Access Compliance Report

Public Rights-of-Way

| Intersection ID: 31346 | Main Street: COCHRAN_FARM_LN | Cross Street: W_SUGAR_CREEK_RD | Location: E |
| ADA ID: 44CF43113DE9 | Ramp Type: Perp | Initial Pass/Fail: Fail | Overall Compliance: No |

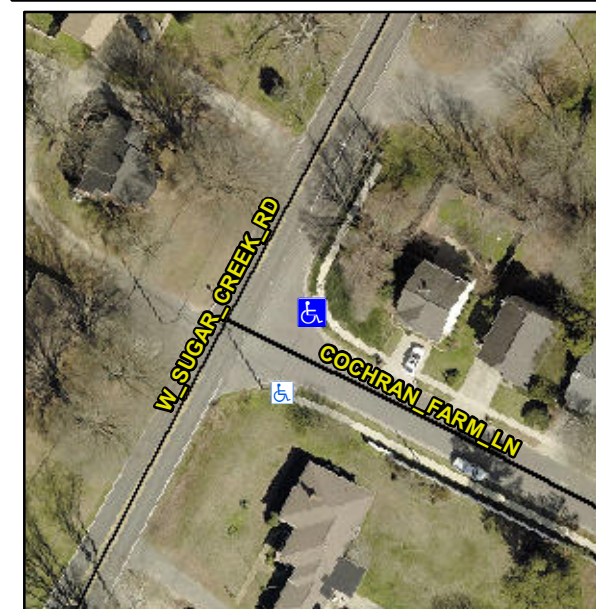
R304.2.2

| Compliance | Description | Data | Compliance | Description | Data |
|------------|-----------------------|-------|------------|-----------------------------|------|
| N/A | Ramp Length (in) | 48.0 | No | Ramp Slope (%) | 10.4 |

Remove & Replace Entire Ramp.
